Environmental Assessment and Finding of No Significant Impact for the Christopher M. Crane Clean Energy Center Reauthorization of Power Operations Project Final Report

Docket Number: 50-289

Issued: September 2026

Figure 3-3 Hydrogeologic Cross-Section of the Christopher M. Crane Clean Energy Site. Adapted from: CEG 2026-TN12942.

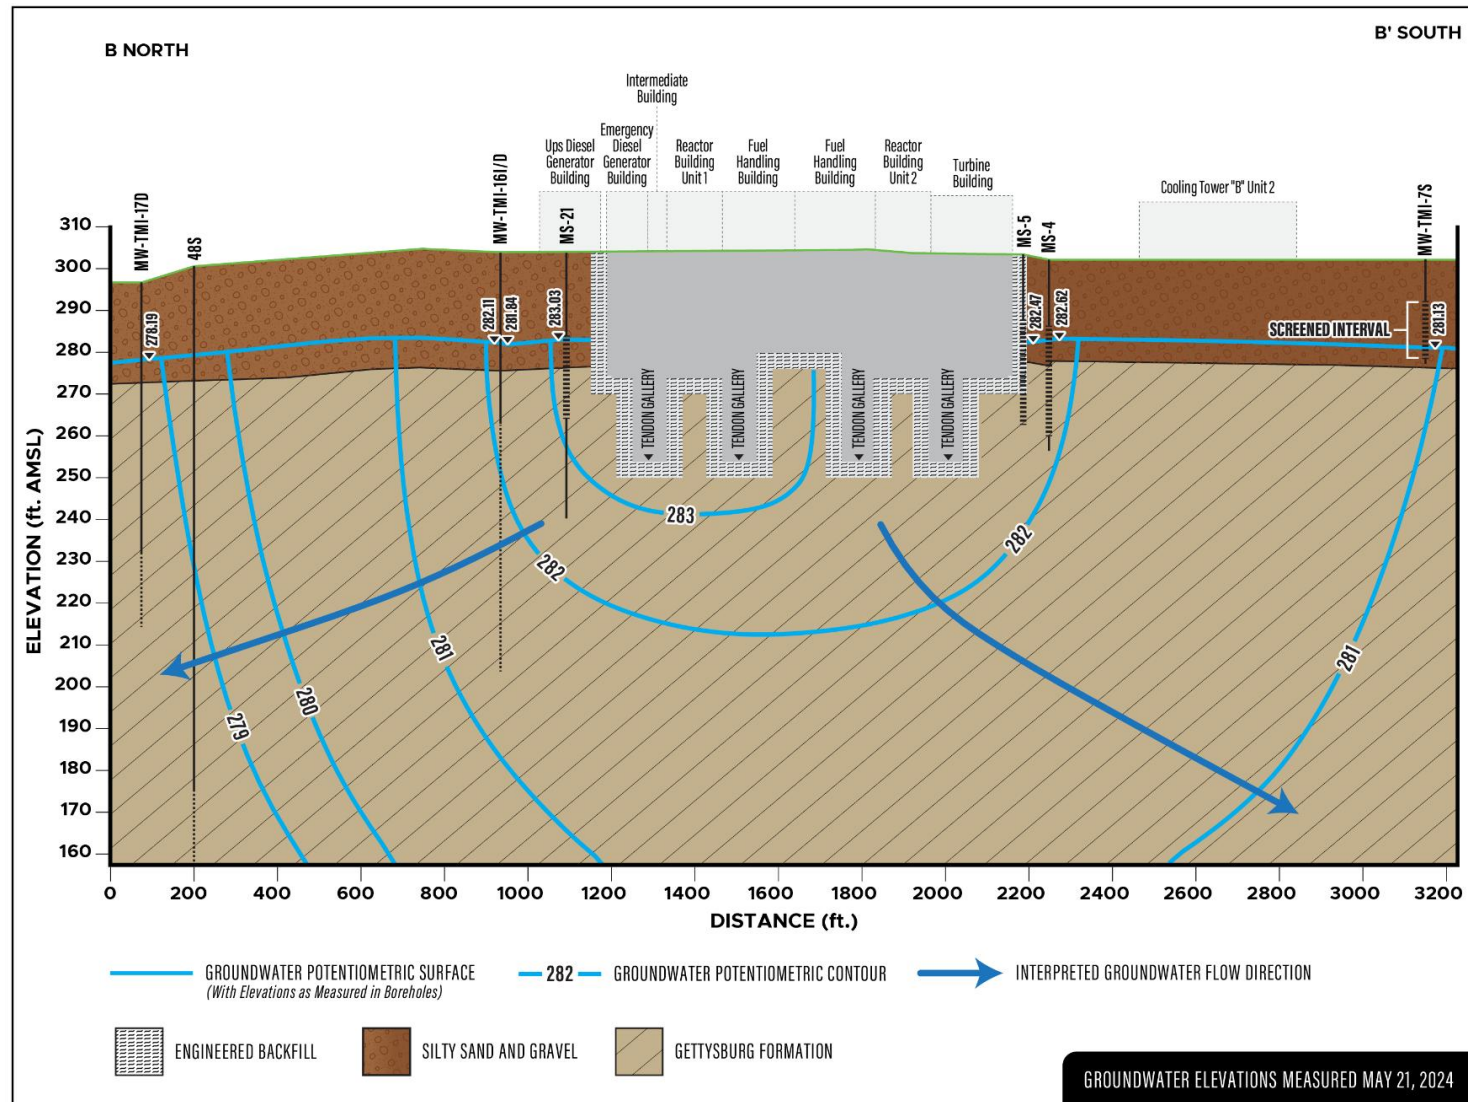
Comment: Figure 3-3

In Section 3.5.1, page 3-17, line 34, it is indicated that the cross-section illustrates the approximated dip of bedding planes in the Gettysburg Formation bedrock; however, the dip of bedding planes is not indicated in the legend for Figure 3-3. **(5-14 [Moore, Dennis M.]**)

Figure 3-4 Area of Potential Effects and 1 mi Buffer Area at the Christopher M. Crane Clean Energy Site. Adapted from CEG 2025-TN12656: Figure 3.5-1.

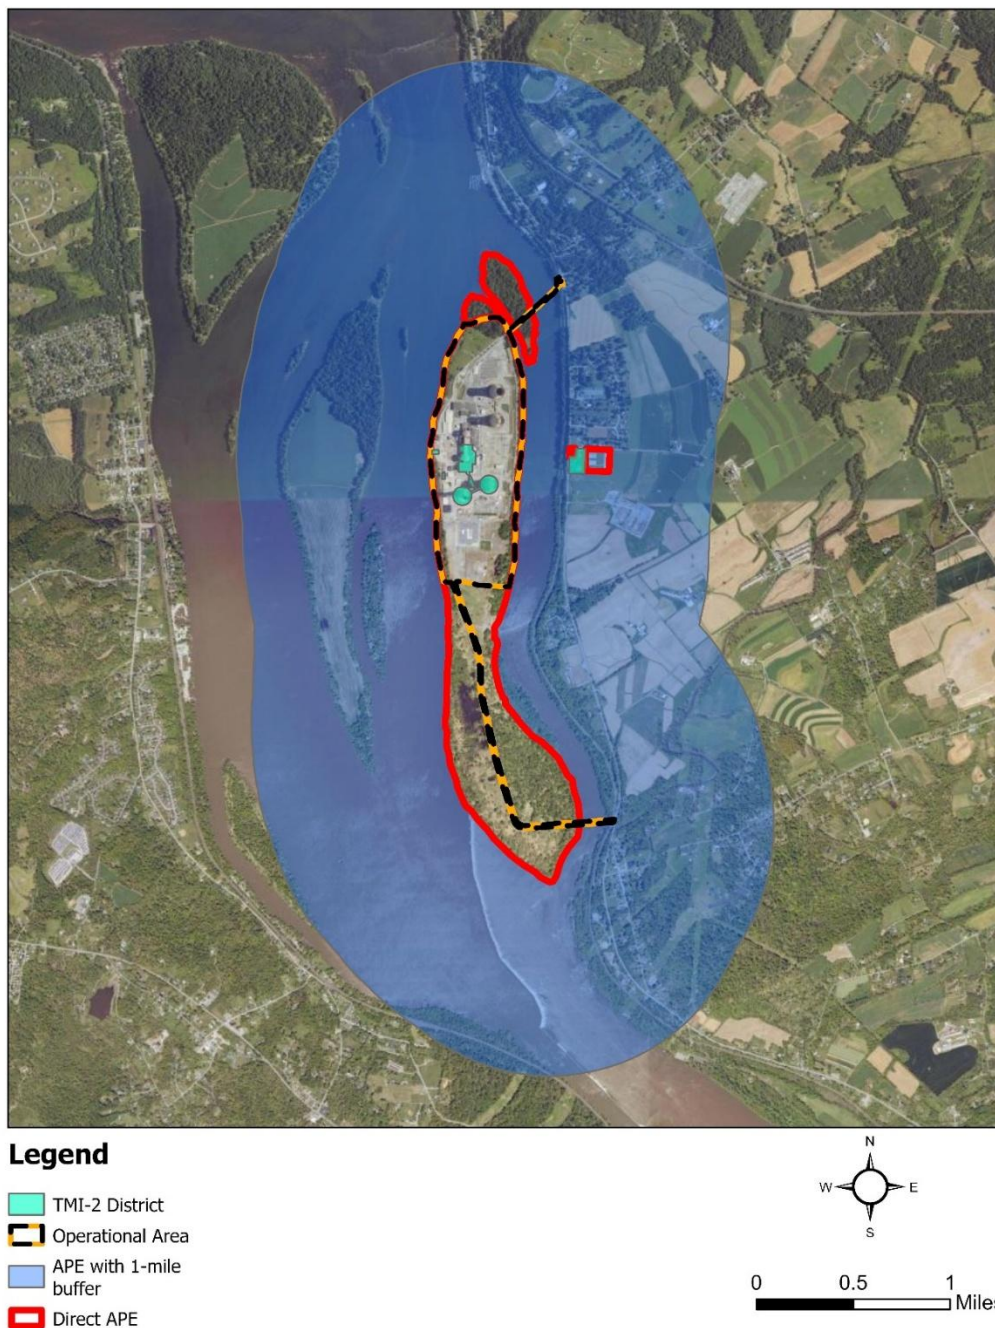
Comment: As indicated in E1.1 (Terrestrial Environment), a newly constructed nature-like fishway (NLF) exists on the southern portion of the CCEC site and the structure is within the 1-mile buffer area indicated in figure 3-4. The construction of this NLF was negotiated and undertaken over the last several years as provided for in the 2015 Federal Energy Regulatory Commission (FERC) relicensing of the York Haven hydroelectric project (FERC #: P-1888). The potential for withdrawal/discharge from the CCEC and its impact to aquatic life utilizing the NLF was not fully considered during its design. The construction of the NLF returned historic riverine functionality to this reach of the Susquehanna River and its operation is critical to the long-term restoration of migratory fish populations within the Susquehanna Basin. The PFBC considers the NLF to be a significant aquatic ecological resource within the CCEC site and is deeply concerned that the existence of the NLF is not acknowledged, and the potential impacts from the proposed action are not further analyzed in applicable sections of the EA. The PFBC is further concerned that the reauthorization of the CCEC and the associated effluent may result in significant alterations to the thermal profile of the NLF deterring migratory and resident species from utilizing the NLF, thus reducing the ability of these species to access critical spawning habitat or directing migrating fish towards the York Haven Hydroelectric Project which has been shown to be a significant source of mortality for out-migrating American Eel and American Shad. Specifically, the PFBC recommends that NRC include the following in the final EA:
